Docket No. 50-213  
B12882

Haddam Neck Plant  
Additional Information Relating to  
Small Break LOCA Analysis Model, NULAP5 (TAC No. 45830)

Response to NRC Questions  
About the  
Oxidation Model in NULAP5

# HADDAM NECK SWELL AND RUPTURE MODEL

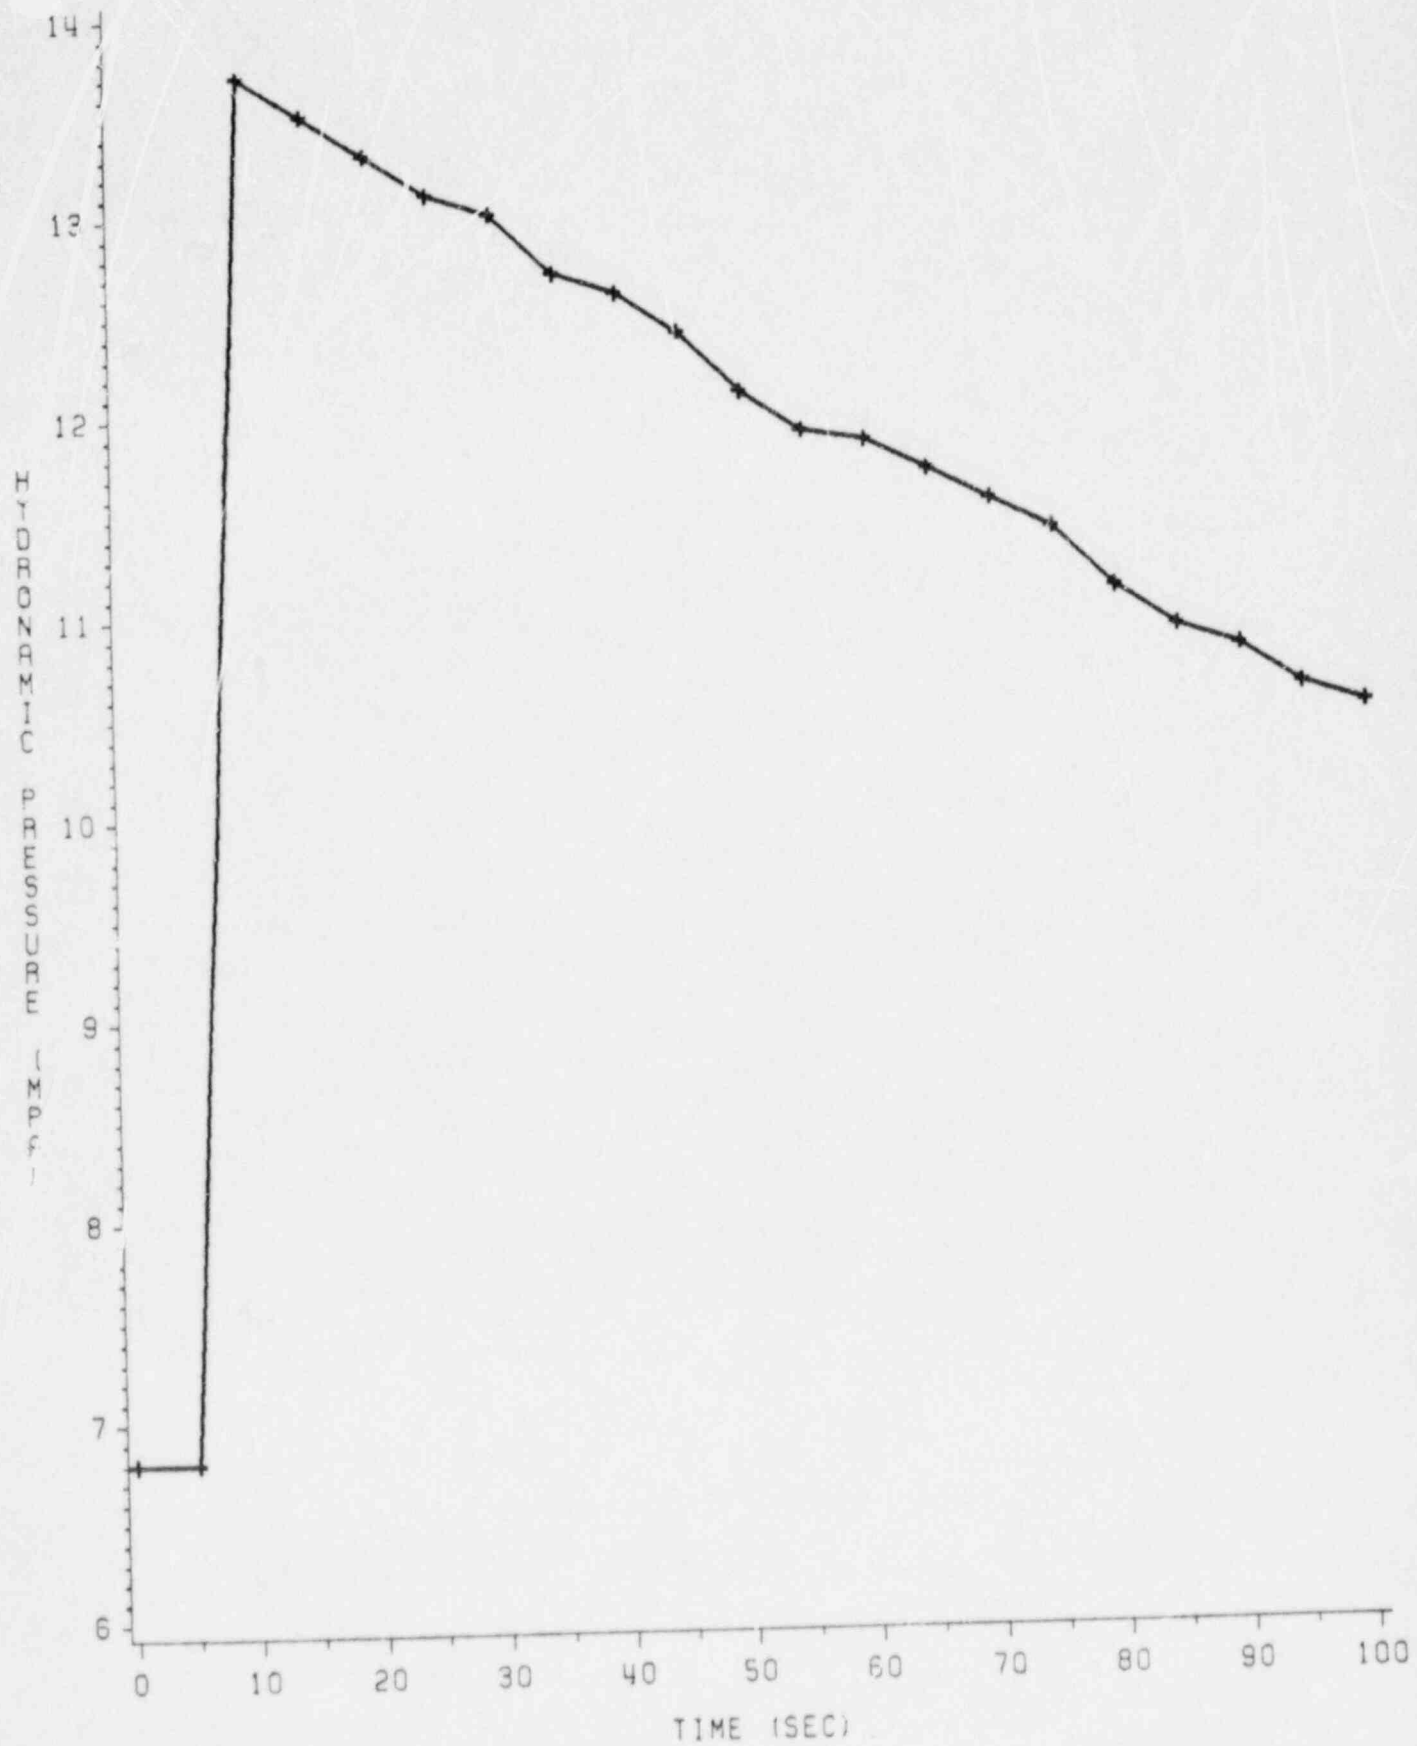
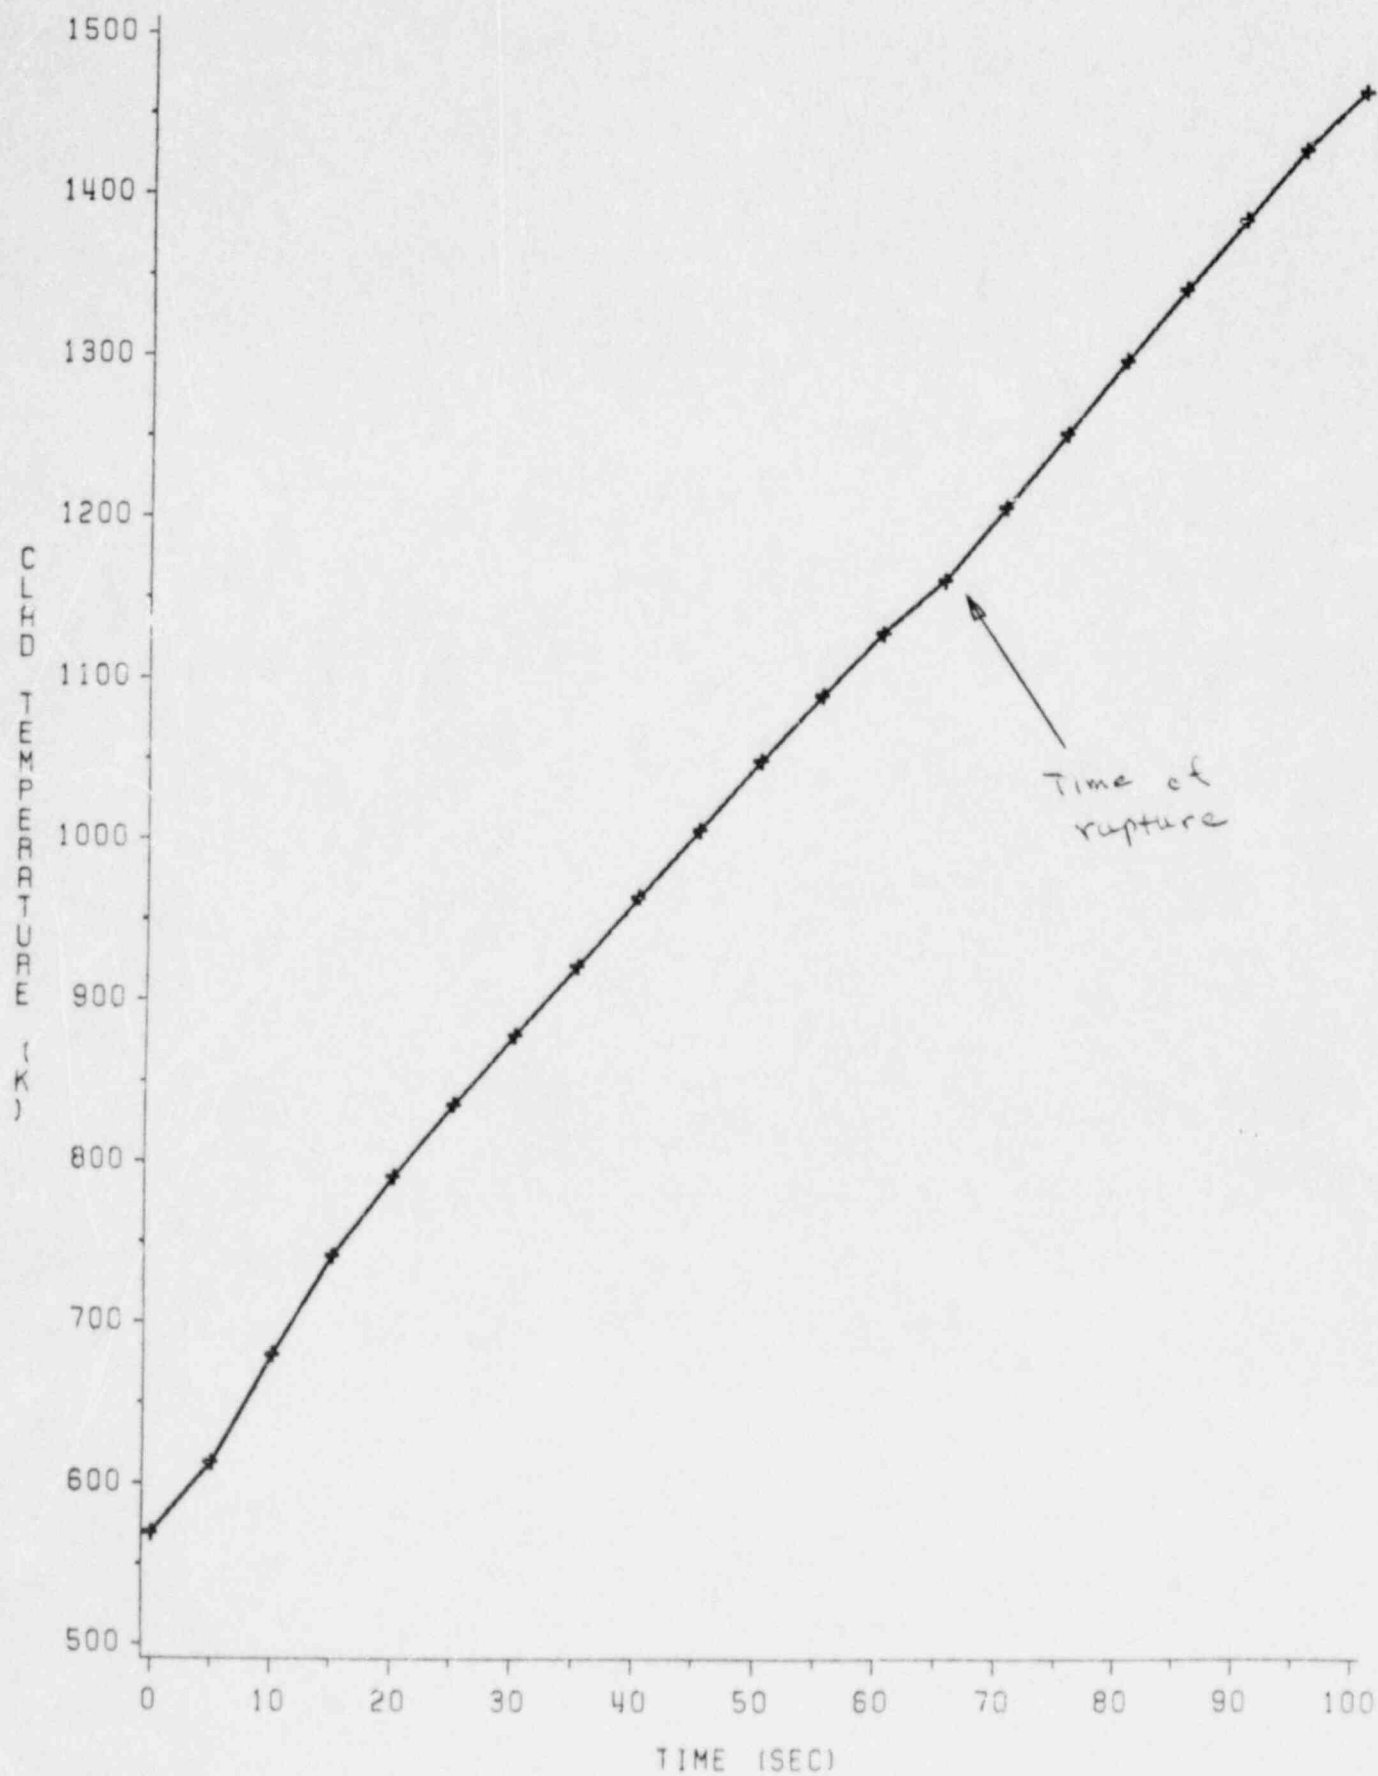
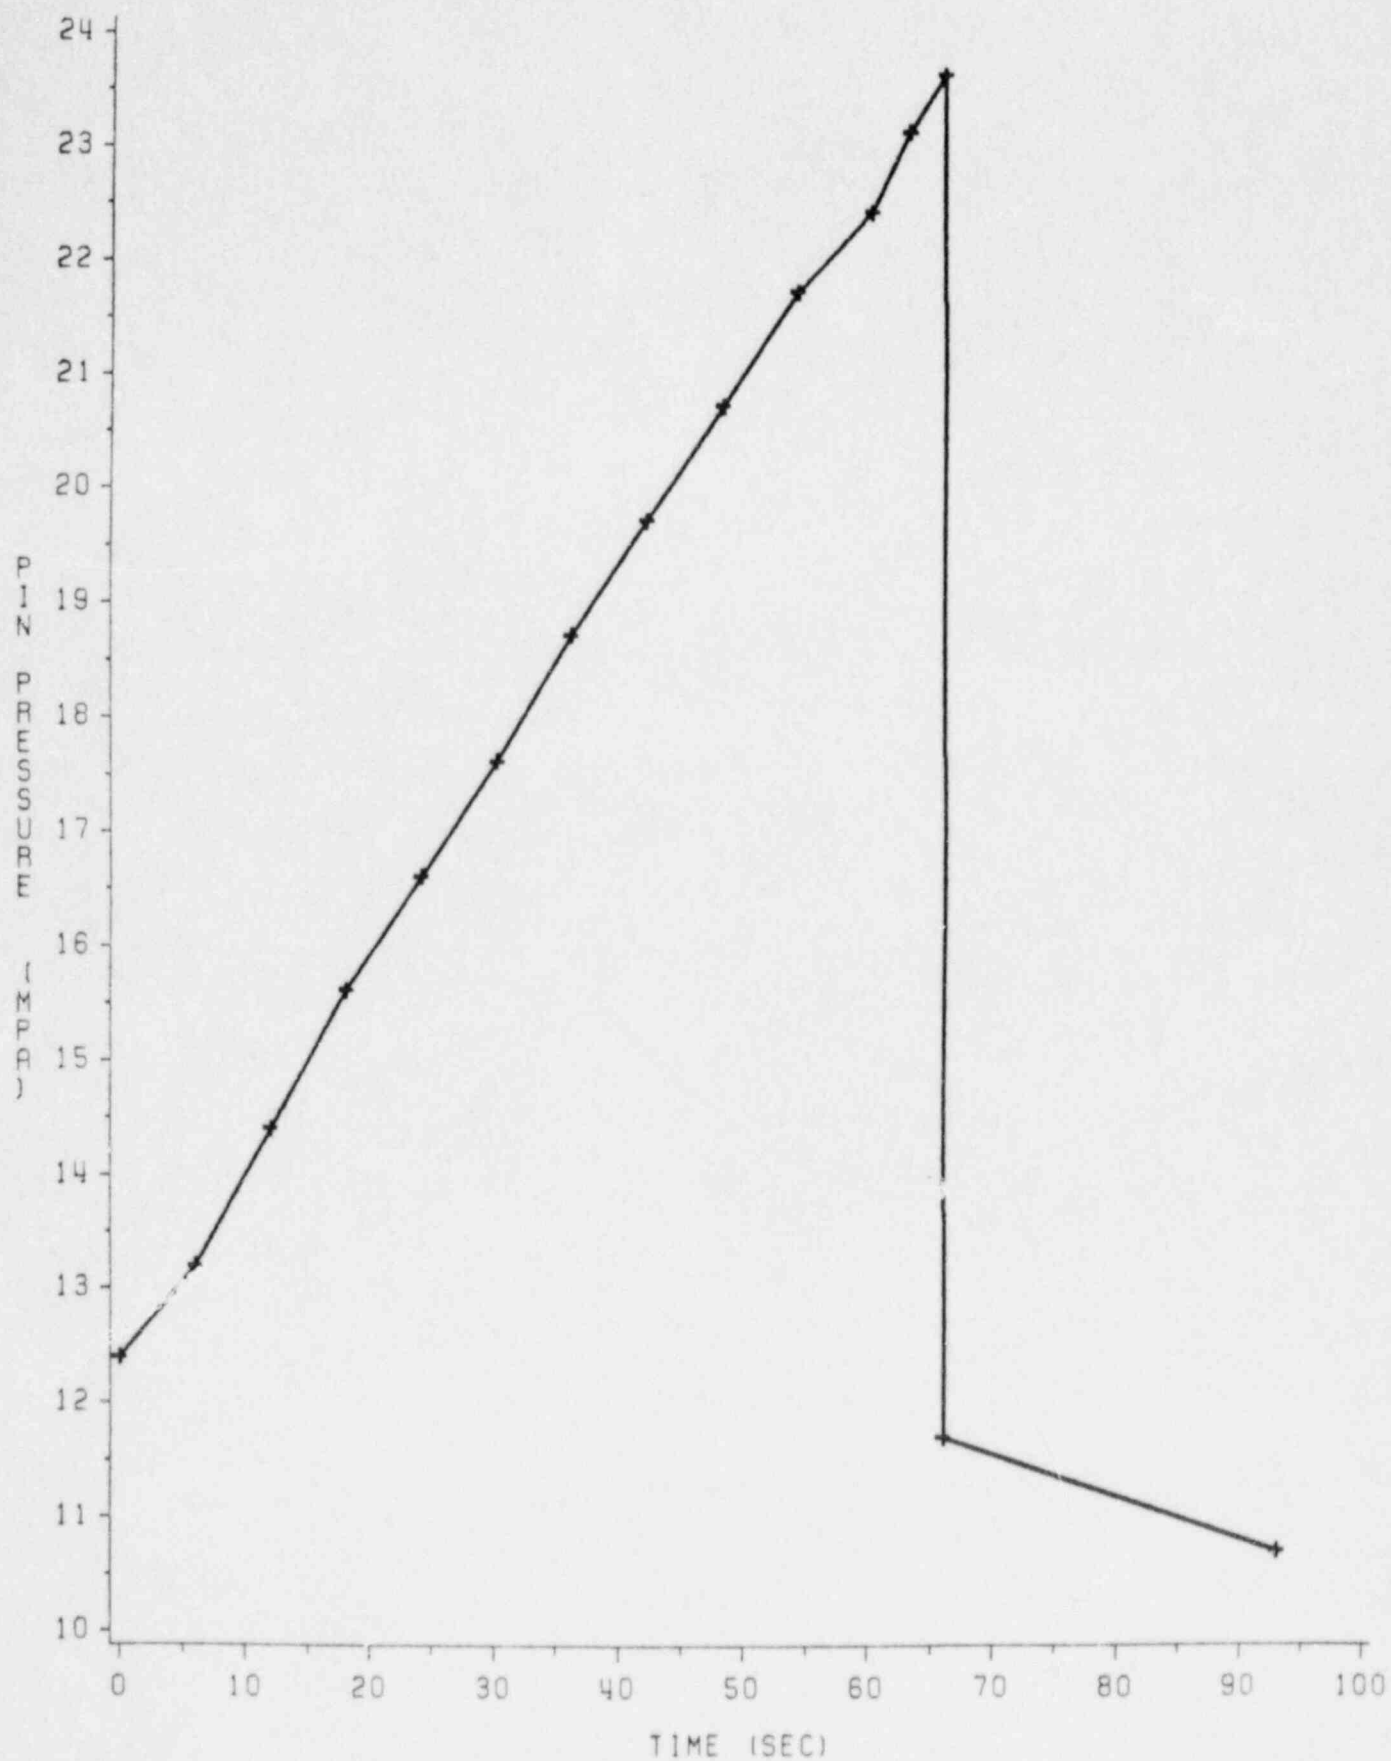
Attachment 2 contains information previously provided to the NRC's consultant regarding the response of the clad swell and rupture model in the SB-LOCA analysis. These calculations and plots show that the rupture model behaves as it should and is consistent with the internal tables of the SB-LOCA code.

This attachment contains information regarding the response of the clad swell and rupture model in the SB-LOCA analysis. To provide this information tests were run with a pipe for the hydrodynamic boundary condition and heat structures to simulate a Haddam Neck fuel rod. Three tests were run at different initial pin pressures but all other initial conditions were kept unchanged. Table 1 of this attachment contains a summary of the results of the calculations. Plots of temperature vs. time and coolant pressures vs. time for the 1800 psi case are also included. All three test runs ended at about 102 seconds when the clad temperature caused a water property failure. These calculations show that the rupture model behaves as it should and is consistent with the internal table of the SB-LOCA.
